**ADDENDUM # 1**

**CITY OF TORRANCE  
3031 Torrance Blvd.  
Torrance, CA 90503**

**BID NO. B2021-30**

**Bid for Furnish and Install New 400-Amp Panel for Future Electric Vehicle Charging Stations, Concrete Pad  
for Edison's Surface Mounted Transformer and Required Conduits**

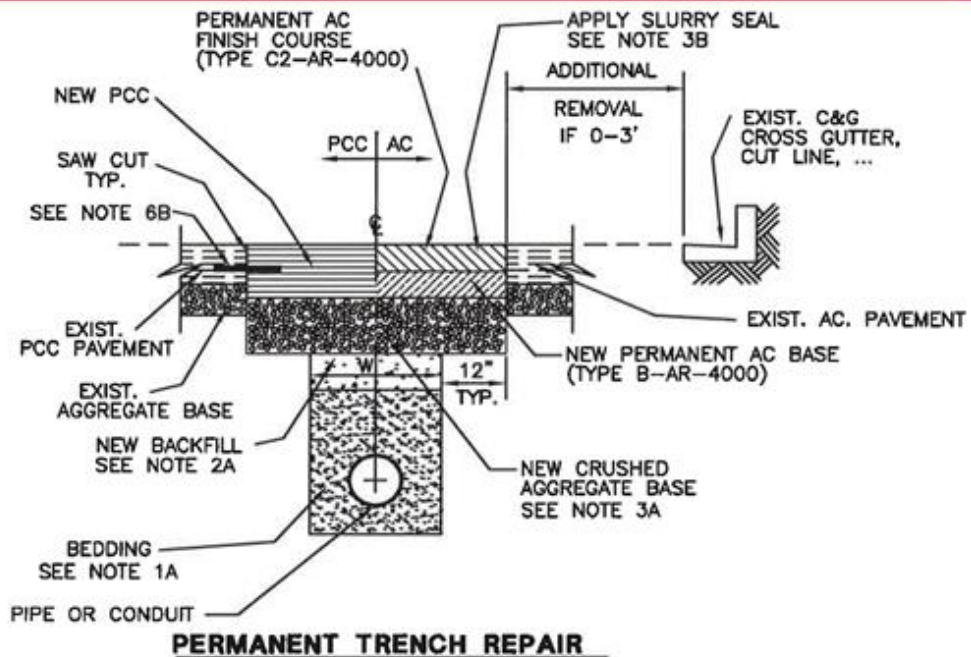
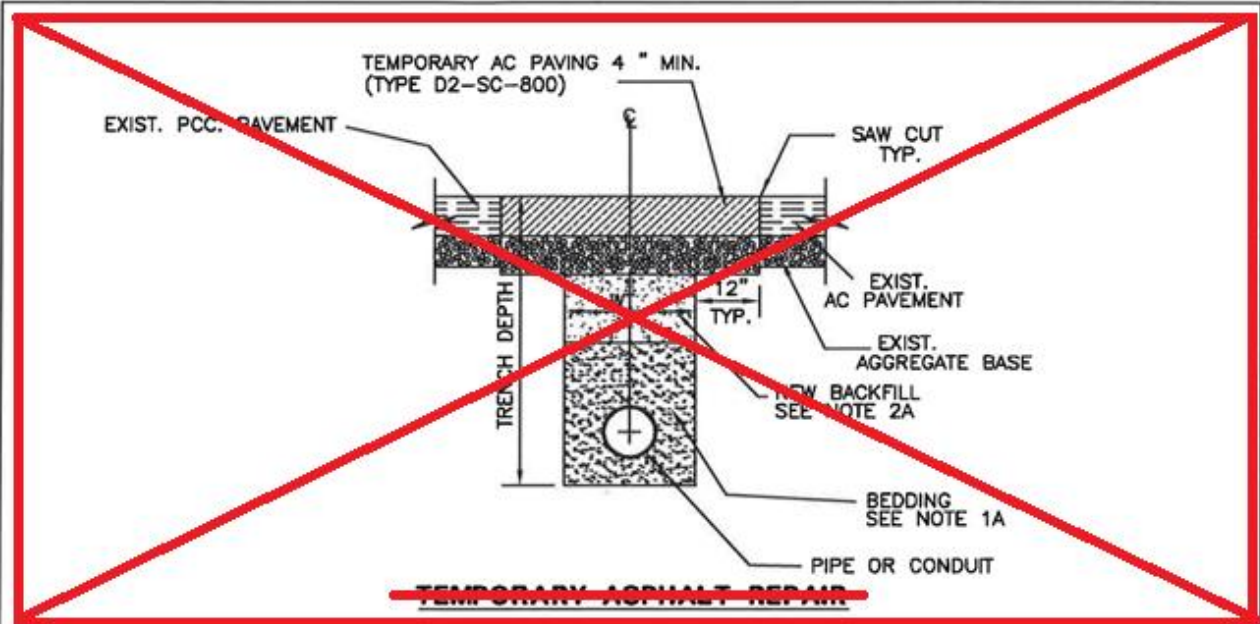
6. Requesting the “tie in” information be added on the SCE drawing.

**As stated on the bid packet page 18, Edison will perform all tie-ins.**

**TRENCH BACKFILL & PAVEMENT REPAIRS**

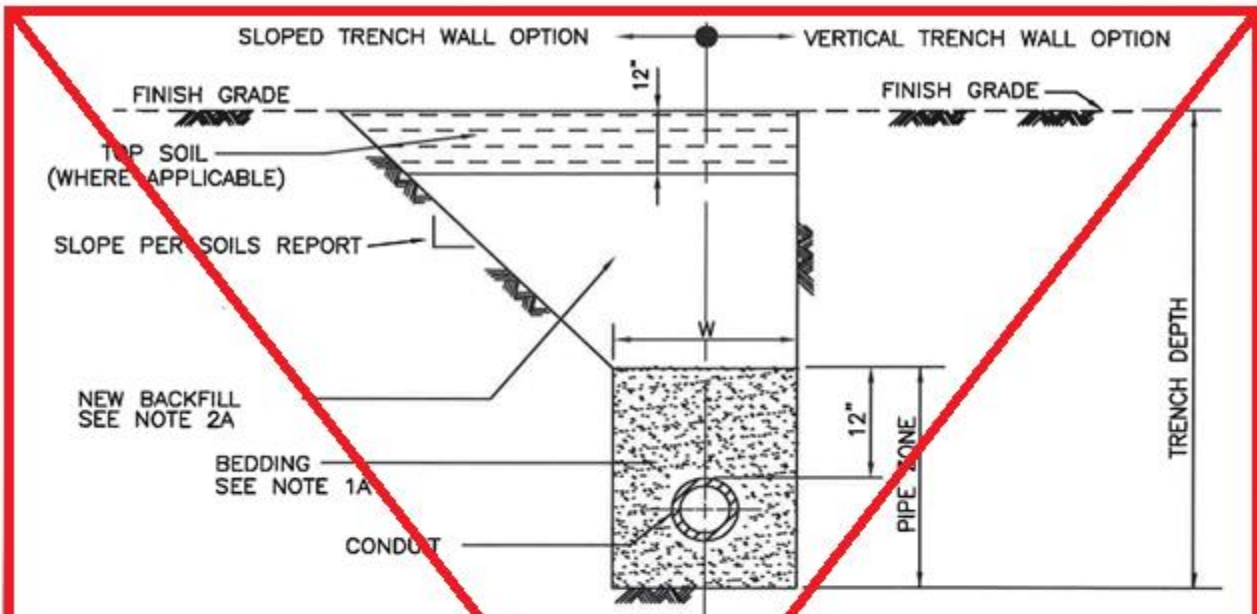
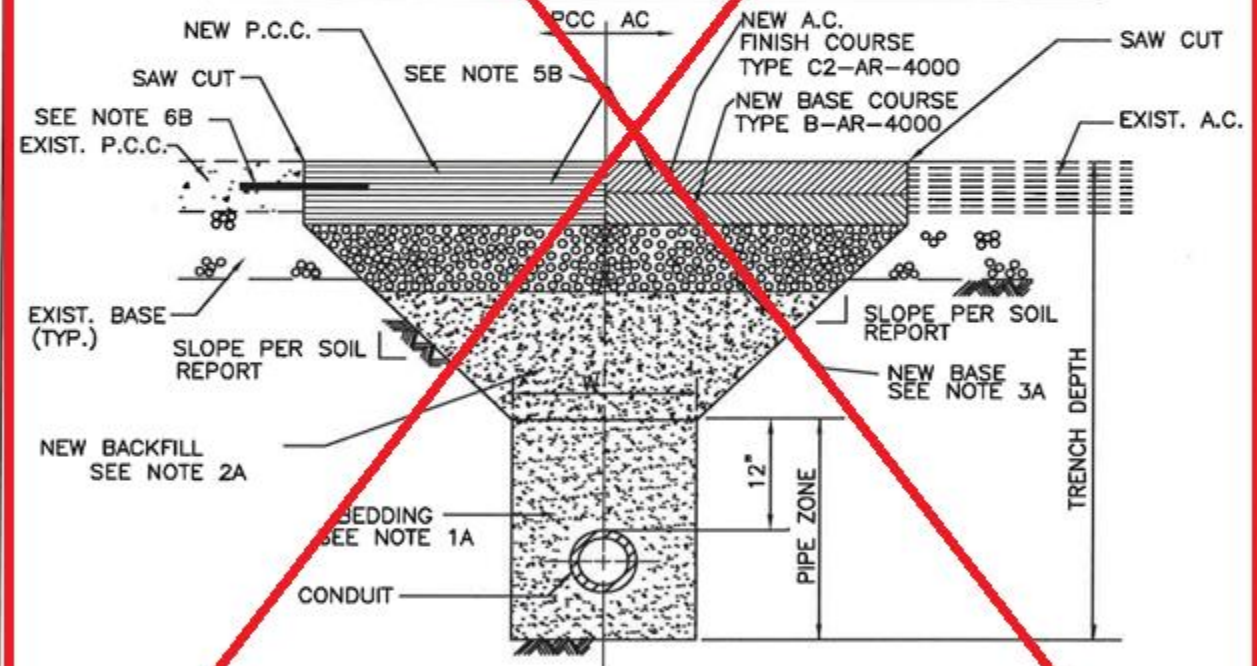
3. Trench line to be pass back, T-cap, or overlap trenching?

**Reference permanent T-cap repair per City of Torrance - Engineer Department attachment labeled T116-2 on pages 3-6. Asphalt concrete (AC) is 1 inch thicker than existing but no less than 4 inches thick. Crushed miscellaneous base (CMB) is 2 inches thicker than existing but no less than 8 inches thick. Please see the attachment on pages 3-6 of this addendum for more trench backfill & pavement repair information.**
